STATE OF MAINE
DEPARTMENT OF TRANSPORTATION
16 STATE HOUSE STATION
AUGUSTA, MAINE 04333-0016

January 7, 2020
Subject: Drainage & Safety
Improvements
State WIN: 019402.00
Location: **Augusta**
Amendment No. 3

Please make the following changes to the Bid Documents:

SHEET NUMBER
41
OF 52

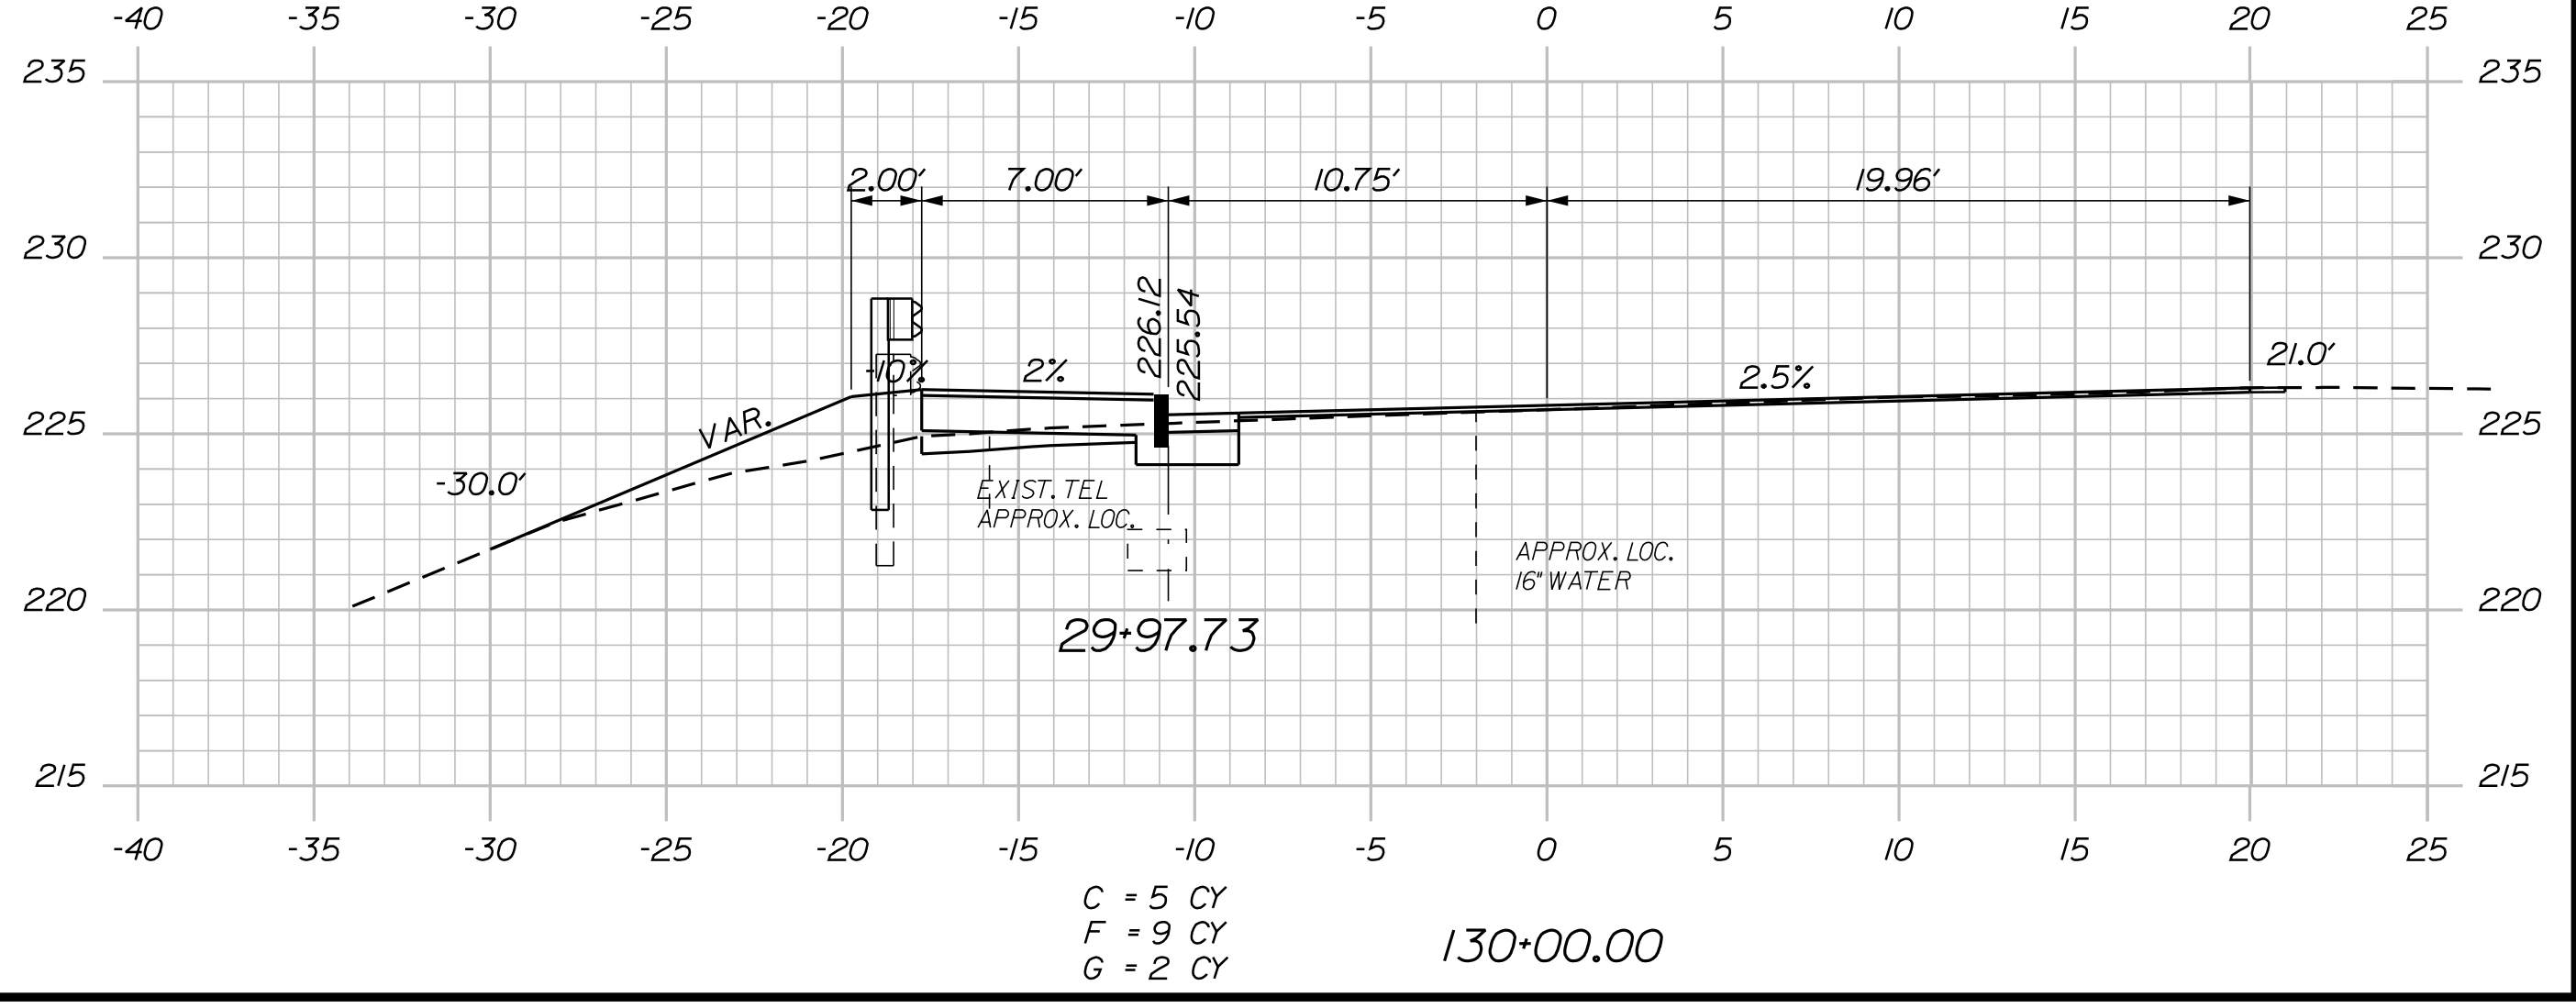
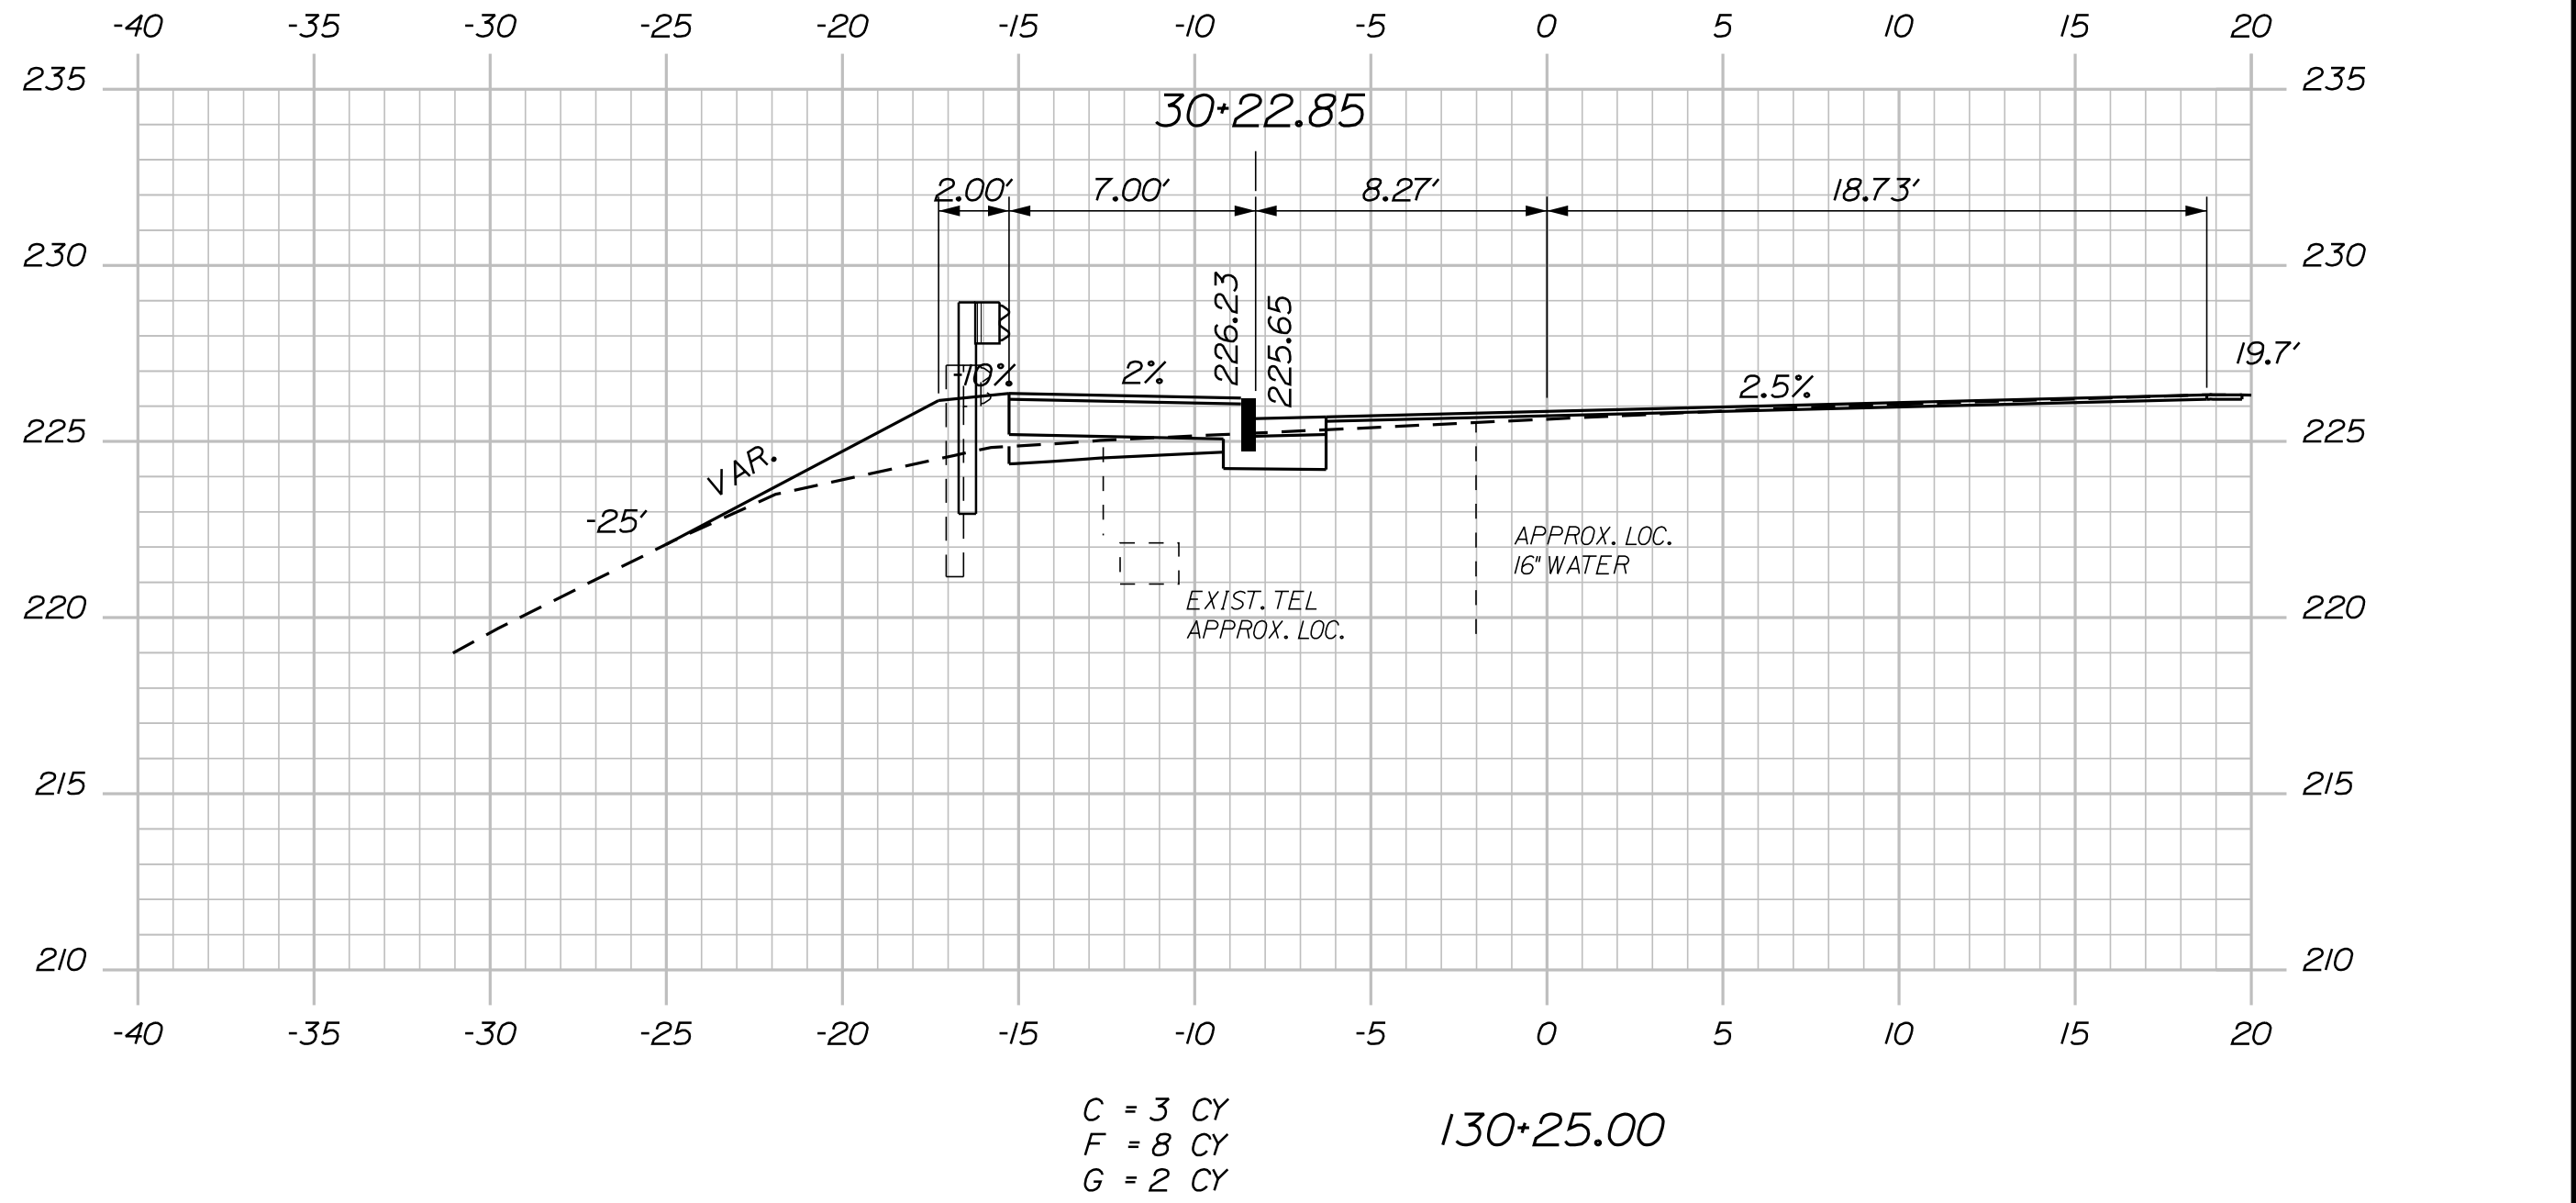
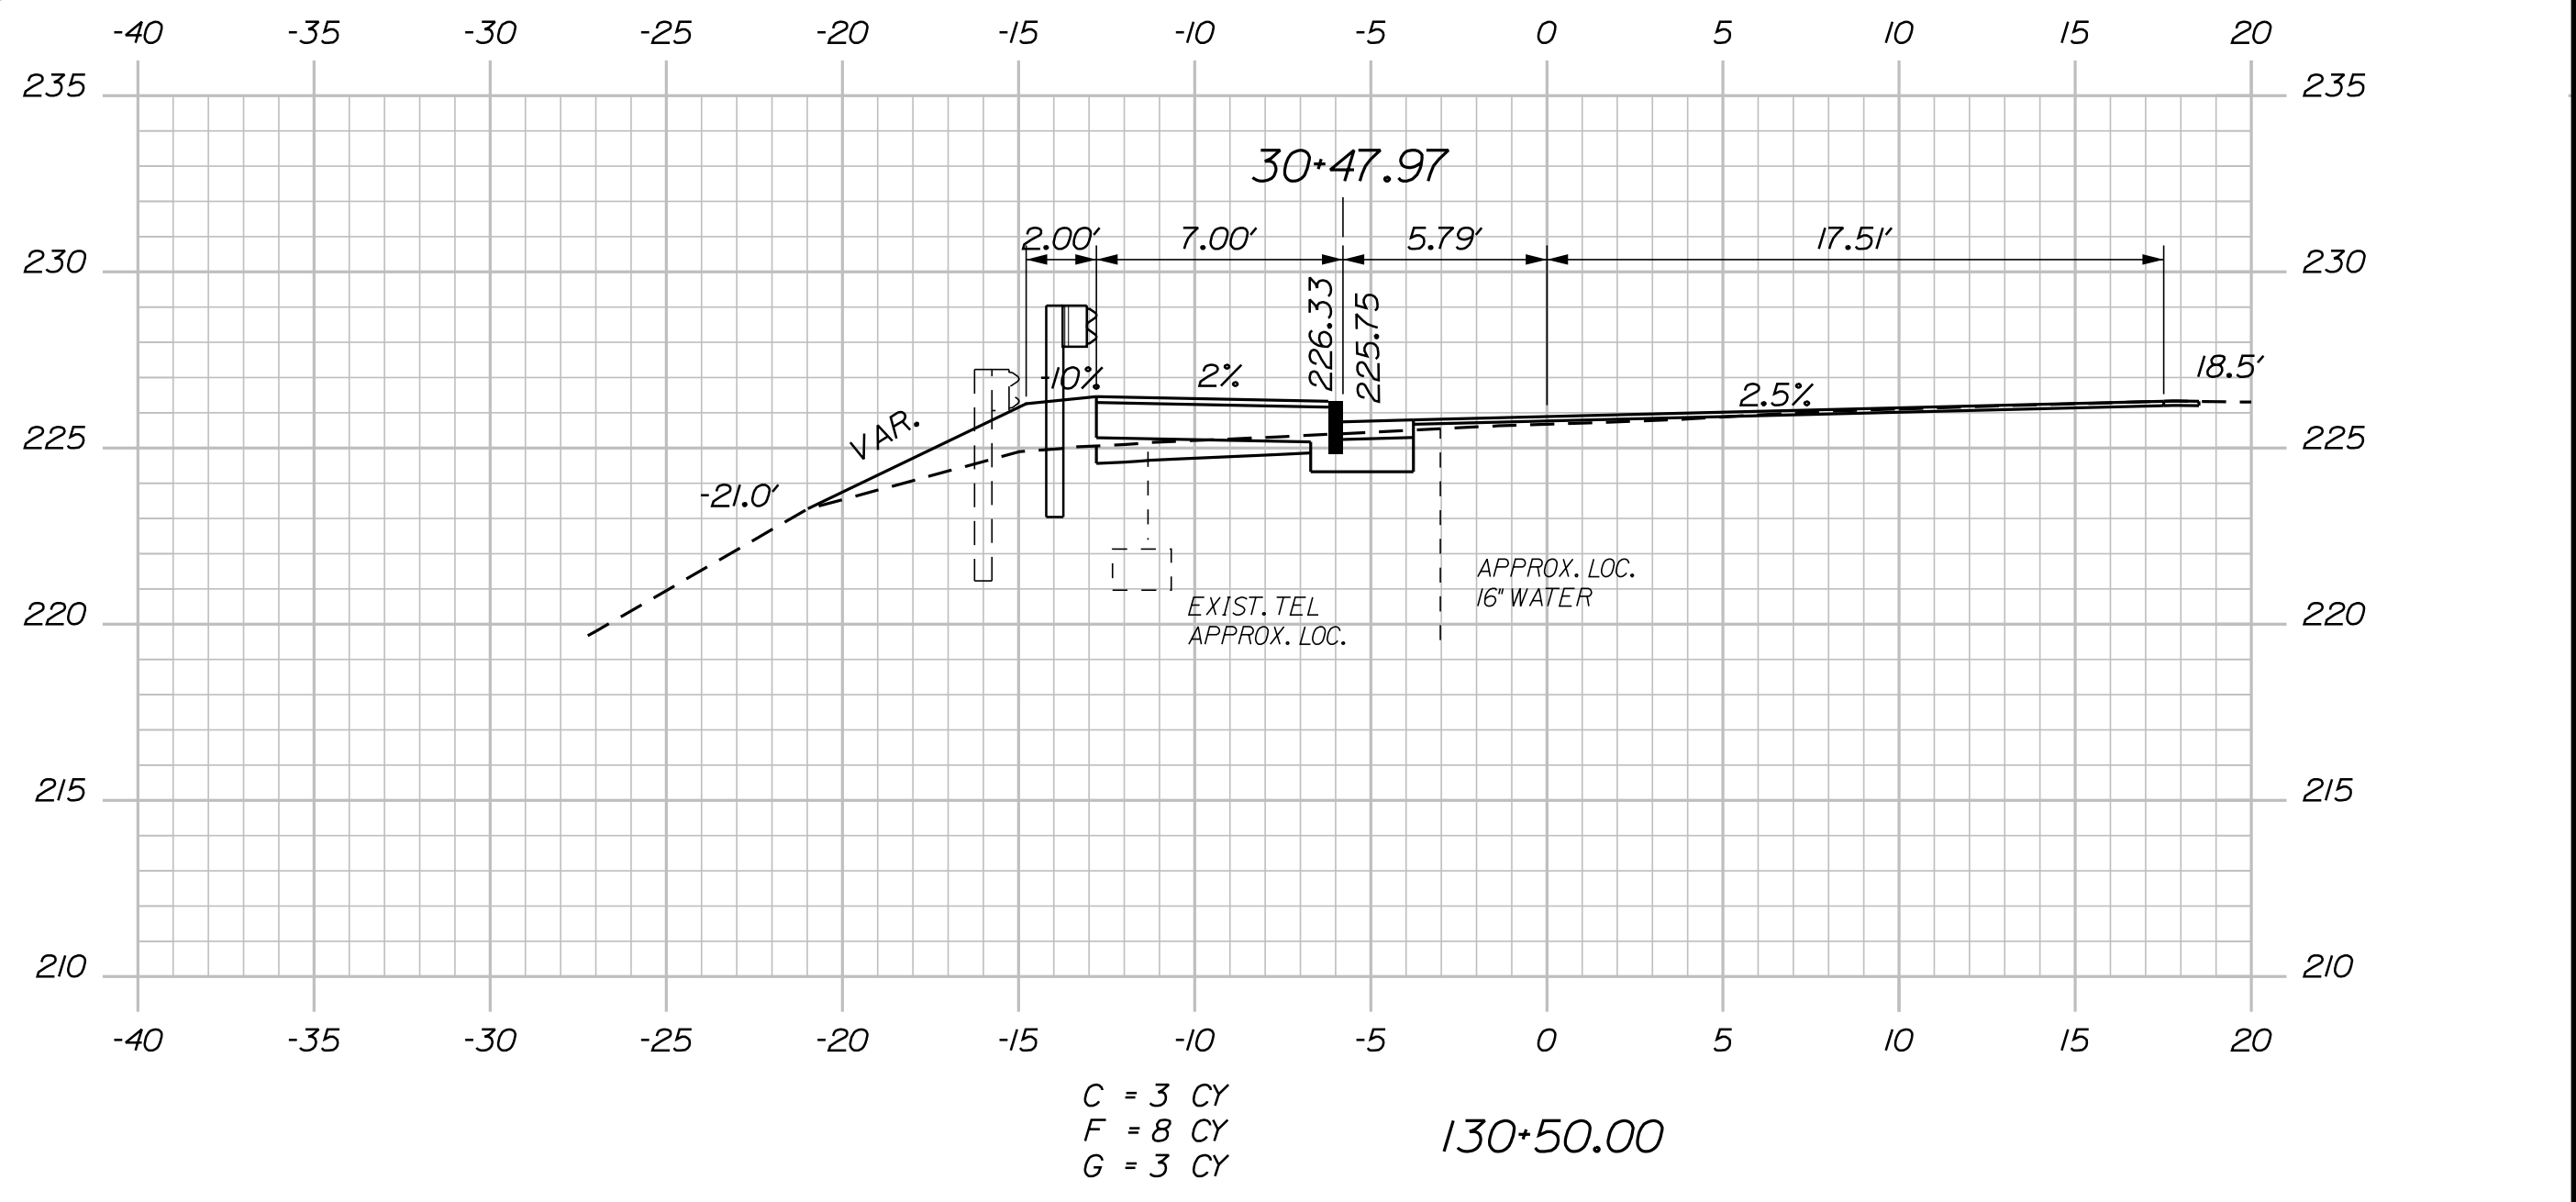
TEST PIT AT BASINS 7&8 TO VERIFY CONFLICT WITH BURIED TELEPHONE CONDUIT PRIOR TO ORDERING SPECIAL BASIN ITEM 604.2403.
